Comment (Comment r02-119, r02-70 clause 145.4.1 page 217 line 39)

Figure 1: Dual-signature, single load PD.

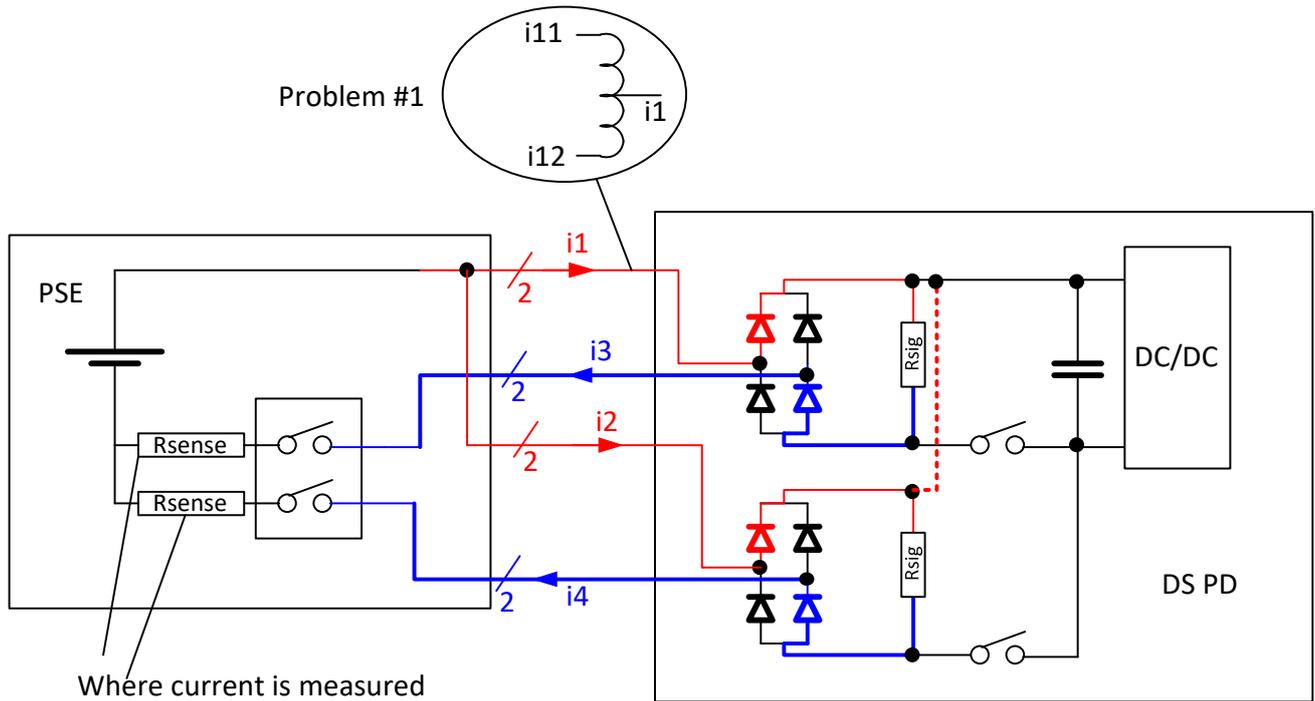
- Switching on the negative is mandatory
- Measuring current on the negative when switching on the negative is the only practical choice since measuring on the positive will result with pairs currents that are not correlated to the negative pairs currents due to unbalance.
- As a result, it is guaranteed only in the negative pairs, that PSE will support PD successfully when measuring the pair current for connection check, detection and classification circuits in dual-signature PDs.
- In addition, the positive side is tied together at the PSE side which effectively, tied the positive pairs at the PD side as well.

Figure 2: Dual-signature, dual load PD.

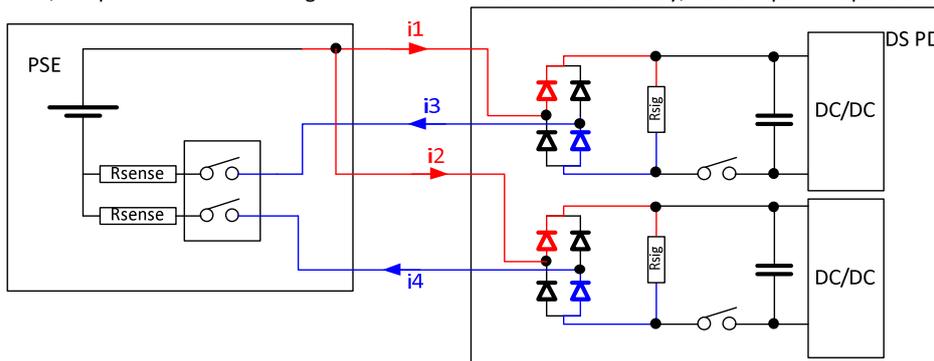
By definition, the positive pairs and negative pairs are isolated in the PD primary side (secondary may have common GND and typically this is the case). However, since as in the previous case the PSE is required to support switching on the negative pairs, PD is not guaranteed to be supported on the positive pairs making the isolation requirements on the PD positive pairs with no value.
